open issues

AGIPD 1.0 meeting 01.04.14

however, there are some issue that have to be understood (and improved)

open issues: output delays

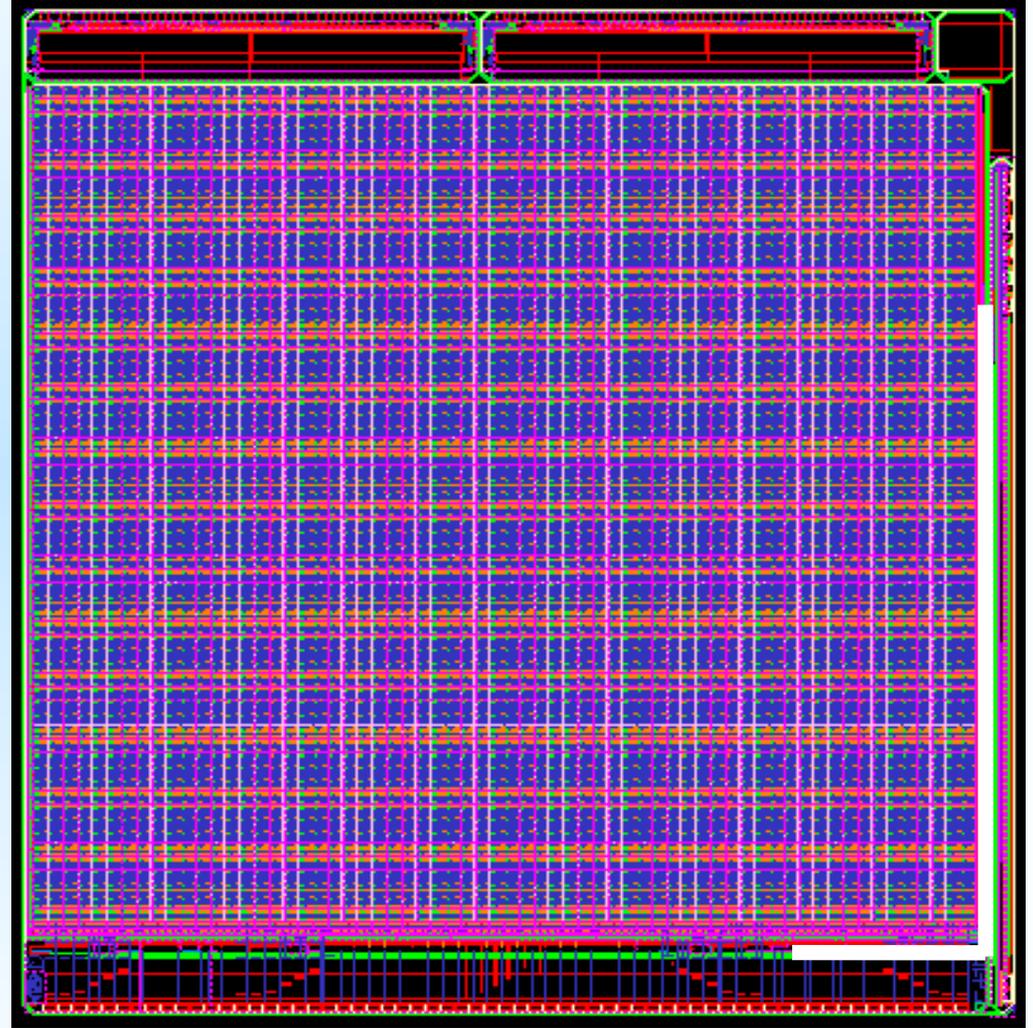
observed: output signals coming from different "quarters" of the chip have different delays.

Slowest ones need a readout rate slower than expected

attributed to: capacitance of the (long) lines is too big for the colbuffer to drive them in the expected times

several possible fixes have been identified

- 1) reduce capacitance load of lines by resizing them. This would be the cheaper (1 mask respin) but the least effective solution
- 2) increase driving power of colbuf
- 3) relocate mux (shorten path of fast signals)

AGIPD1.0 - Chip 1 - Deviation from linear (x12.4 keV) - Bulb

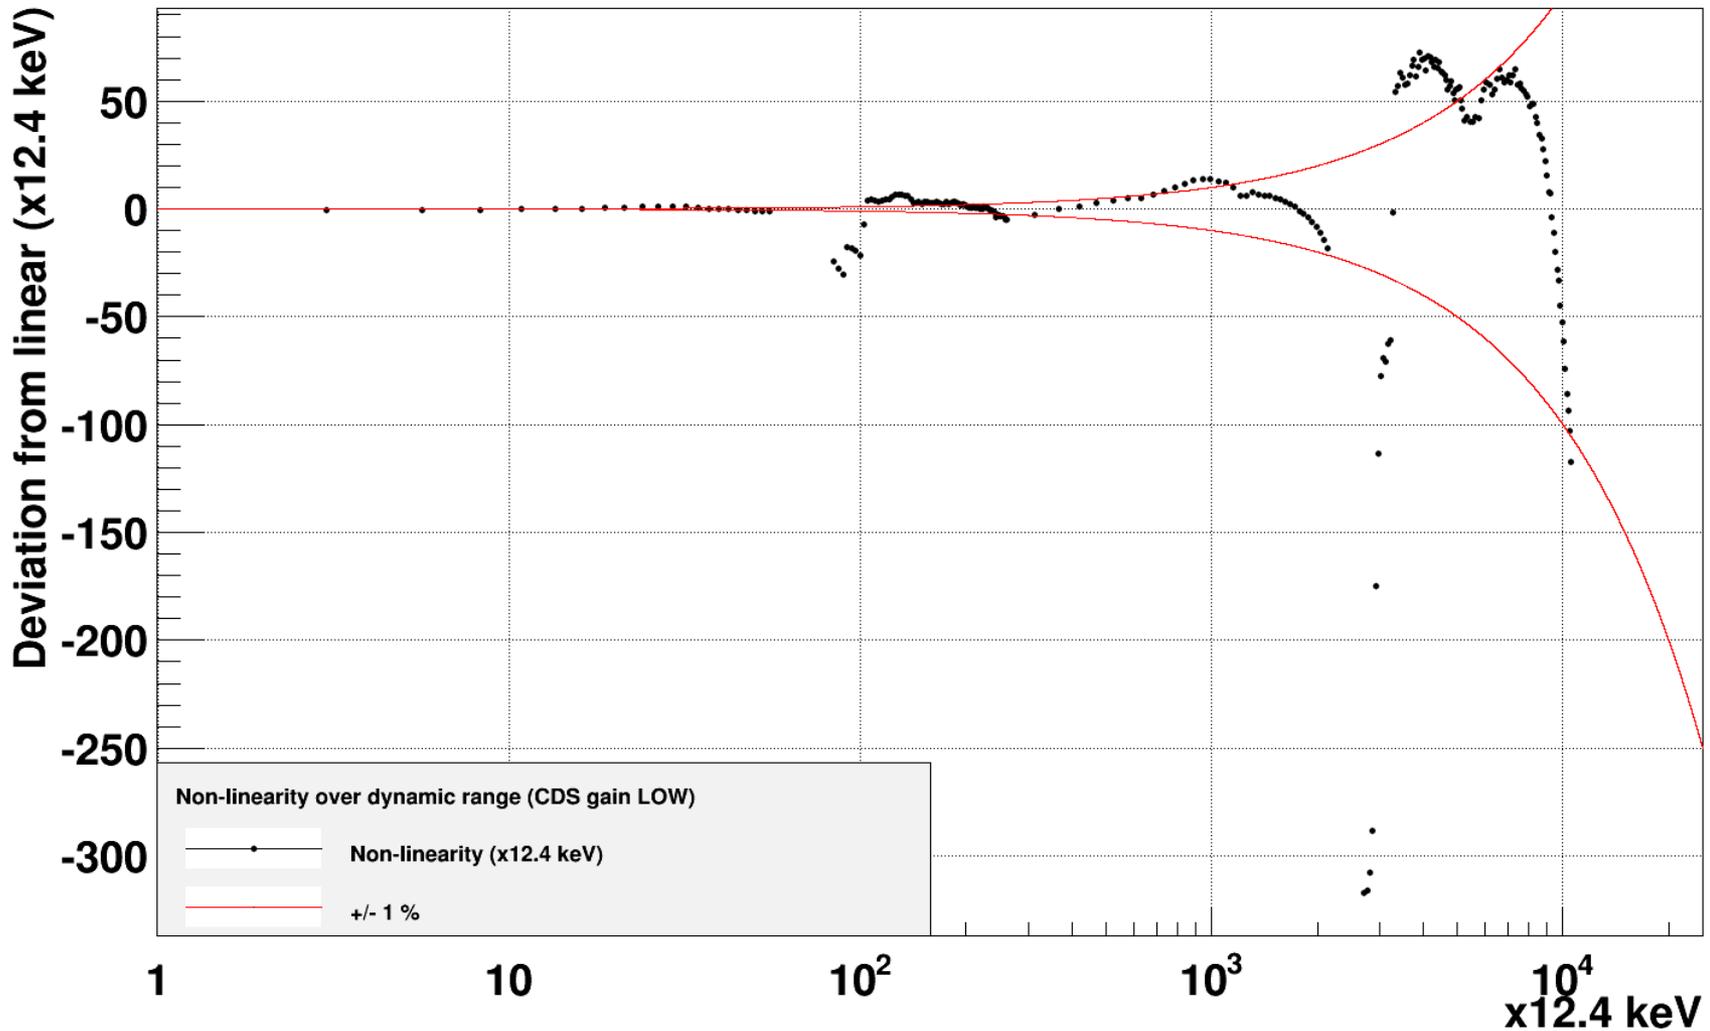
<i>Issue</i>	<i>Potential impact</i>	<i>Comment</i>	<i>Is it a real issue? Fixable in resubmit?</i>
deviations from linearity just before gain switching	potentially avoidable by earlier switching	optimal bias & switching points are being measured (former presentation)	under investigation
deviations from linearity just after gain switching	Medium-high. Most pixels: small monoton. deviations, but non-monotonous responses were observed		under investigation

deviation from linearity

AGIPD1.0 - Chip 1 - Dynamic Range by TEST CURRENT - (Internal Biasing, Chip clock: 40 MHz, CDS gain LOW)

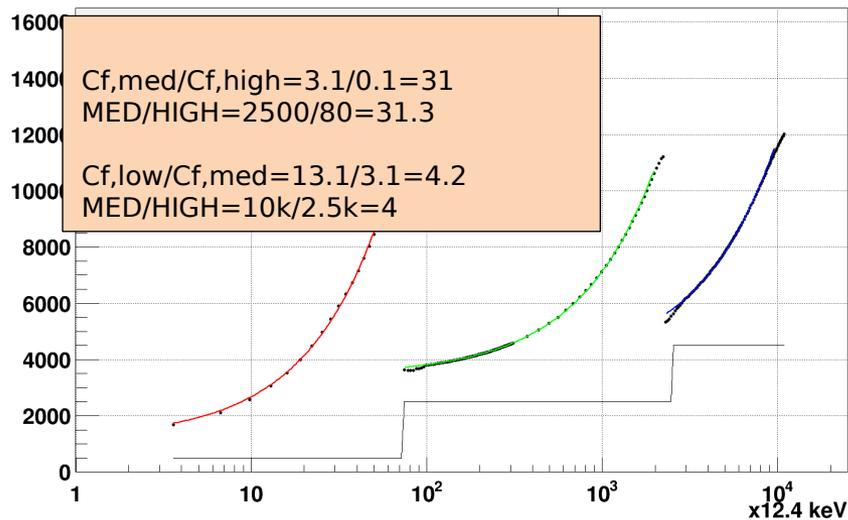
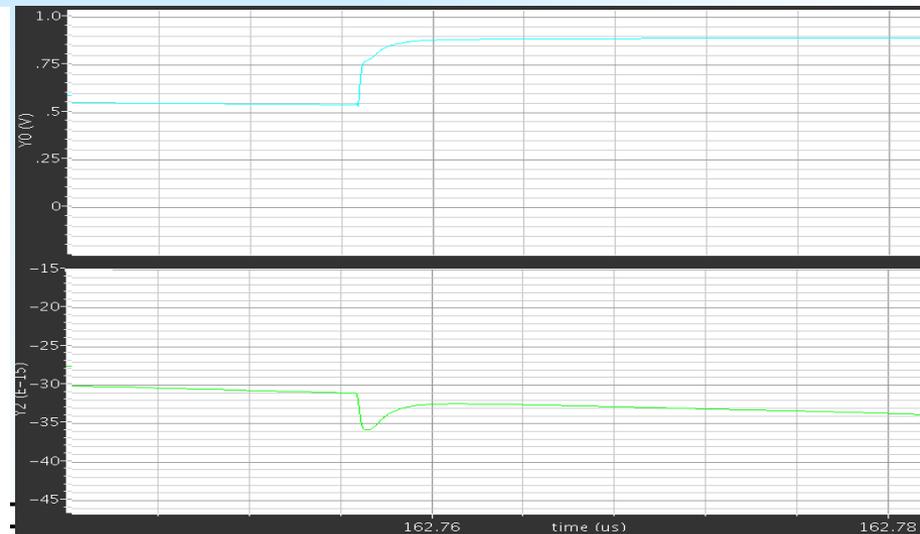
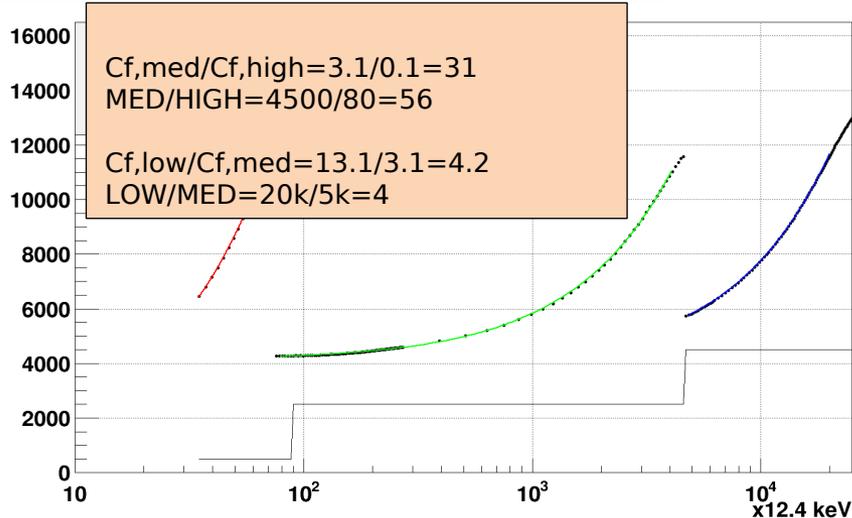
it remains to be seen if the current source (as is now) can be used for calibration

There seems to be an anomalous current variation between high and medium gain.

The current erogated by the current source is the same between medium and low gain, but it is different between high and medium gain.

The variation observed is roughly by a factor of 2; simulations predict a variation much less relevant than that

open issues: digital bits

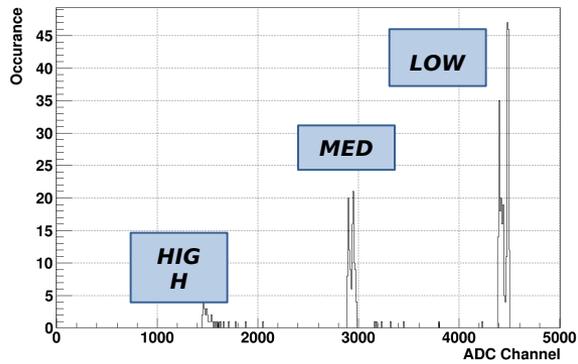
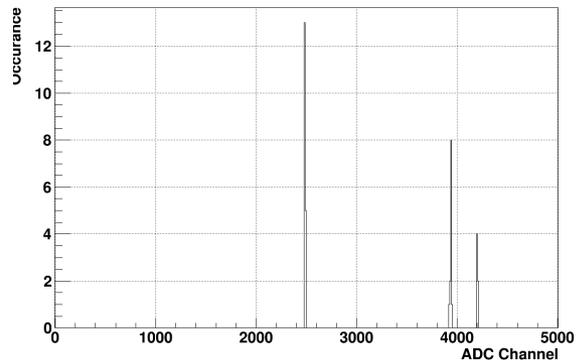
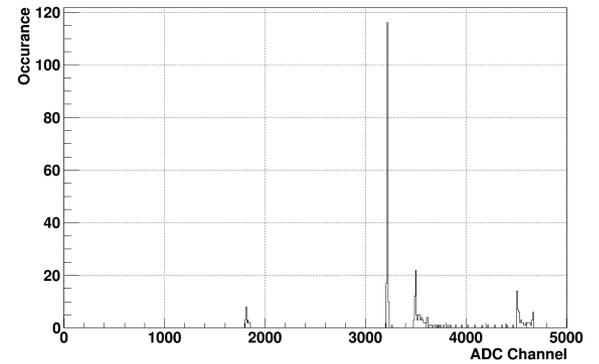
<i>Issue</i>	<i>Potential impact</i>	<i>Comment</i>	<i>A real issue? Fixable in resubmit?</i>
analog-encoded digital values: for some cells are separated by less ADU than their respective noise	Medium, the affected storage cells cannot store digital information reliably, so far 3/4096 ~0.1 % were observed	Might be a yield related problem; measured with not-optimal voltages	under investigation
analog-encoded digital values: somewhat depending on the signal source	Medium-high., affected storage cells cannot store digital information reliably		under investigation

Cross talk between outputs

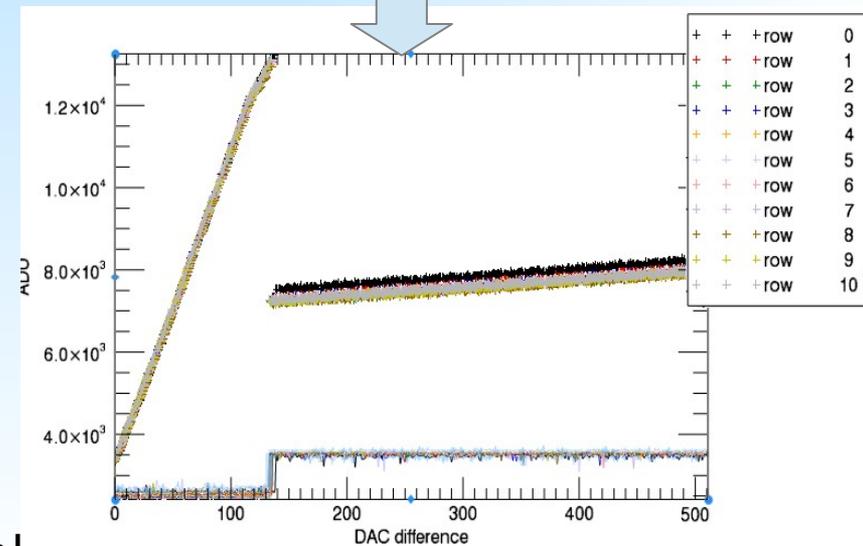
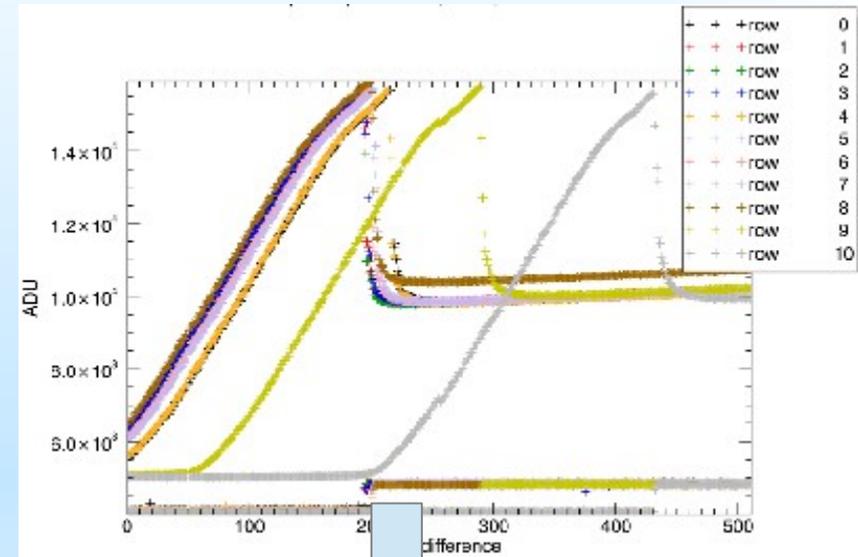
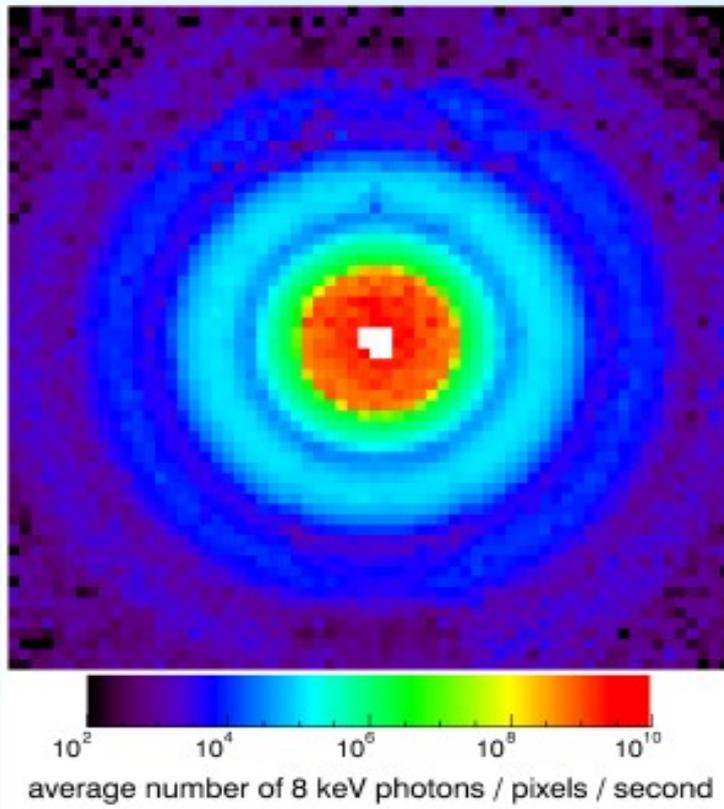
<i>Issue</i>	<i>Potential impact</i>	<i>Comment</i>	<i>A real issue? Fixable in resubmit?</i>
Sometimes positive spikes are observed on the first pixel read and negative spikes on all others	Depends on reason for this cross talk. avoidable by proper sampling	This is probably a chiptester box timing problem coupled with non-optimal DAC settings	Initial observation probably
Cross talk between outputs	Severe/none, would require fix or additional corrections in the data evaluation chain	voltage drop on a bias distribution line	Investigated/ understood fixable

attributed to: voltage drop on Vref_chipbuf distribution
Not pure voltage bias: substantial current is pulled when the output varies → voltage drop (line resistance) → voltage seen by circuits connected to the line changes. solveable by:
1) larger distribution line
2) better: introducing a buffer stage near the circuit to be biased, to eliminate current-induced voltage drop
